ADDENDUM #4

Citrus Grove Road Phase 5
Project No. 2023-08, Bid No. 23-562

CITRUS GROVE ROAD
DESIGN PHASE V
FROM WEST SR 91 TO BLACKSTILL LAKE
ROAD

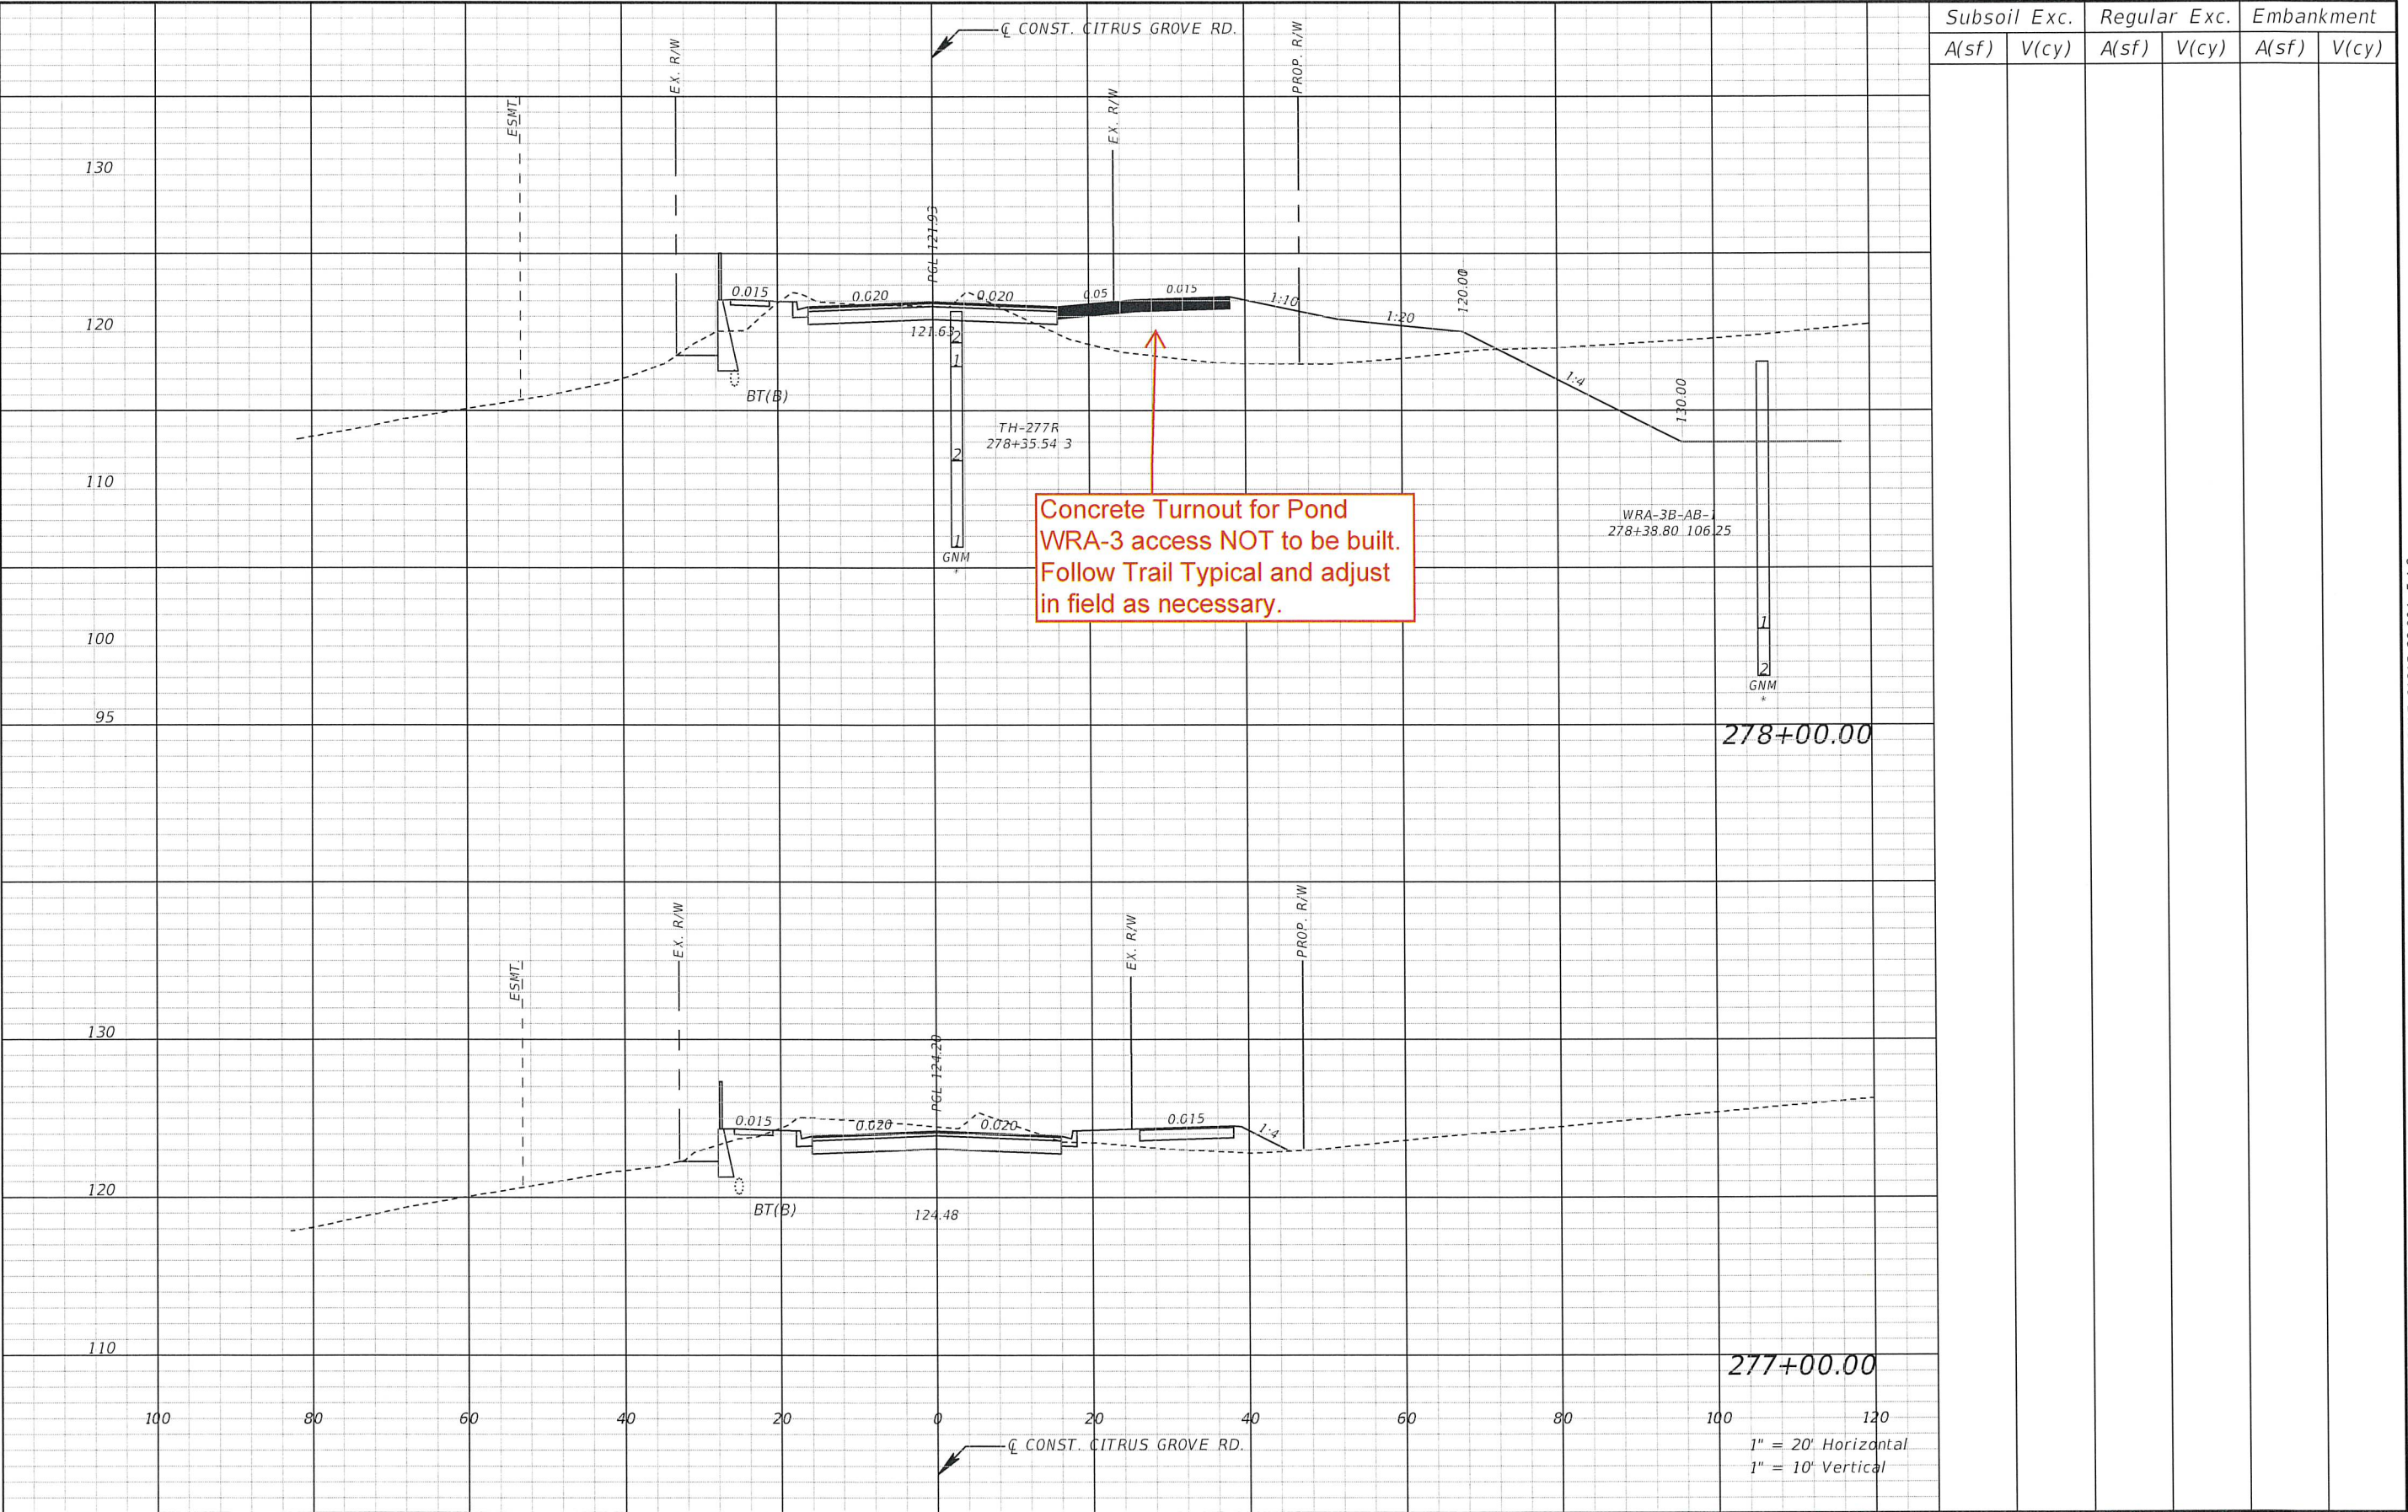
Q3: It appears that Pond WRA-3 is already built. Is this configuration acceptable or will new plans be issued detailing how this existing pond is to be reshaped?

A3: The Pond WRA-3 has already been built by Willow Ridge subdivision and has already been re-shaped; however, outfall pipe of this roadway plan needs to be built. Please see attached revised plan sheets 1, 21, 33, 35, and 63 contained within Addendum #4.
